Point Beach Nuclear Plant, Units 1 and 2
Dockets 50-266 and 50-301
Renewed License Nos. DPR-24 and DPR-27

License Amendment Request 261
Extended Power Uprate
Clarification of Response to Request for Additional Information

LICENSE AMENDMENT REQUEST 261 EXTENDED POWER UPRATE CLARIFICATION OF RESPONSE TO REQUEST FOR ADDITIONAL INFORMATION

**MOTOR DRIVEN AND TURBINE DRIVEN AUXILIARY FEEDWATER
SUCTION PRESSURE TRANSFER AND PUMP TRIP TIMING**

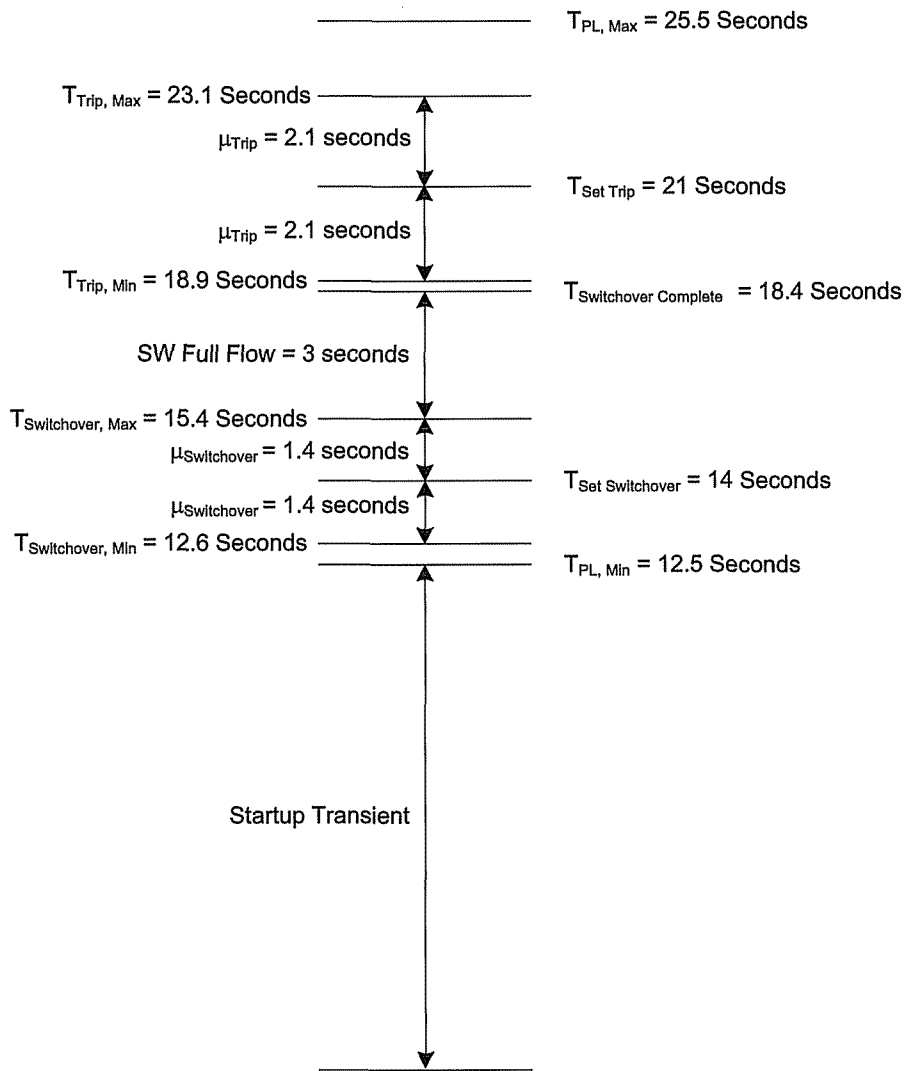
Provide Time response values and the specific design criteria for Figure 2 provided in NextEra Energy Point Beach, LLC letter to NRC, dated November 21, 2009, License Amendment Request 261 Extended Power Uprate Response to Request for Additional Information.

Time response values and specific design criteria for the motor driven and turbine driven auxiliary feedwater pump suction pressure transfer and pump trip is provided in Enclosure 2.

Time $T = 0$ occurs when the low suction pressure is sensed. The Analytical Limit for the low suction pressure is based on the elevation required to ensure that sufficient water (including water pumped during the associated switchover and trip time delays) is available to supply the AFW Pumps until they automatically switchover/trip, thus preventing damage to the pump .

$T_{PL, Max}$ is the maximum allowable time delay for the pump trip.
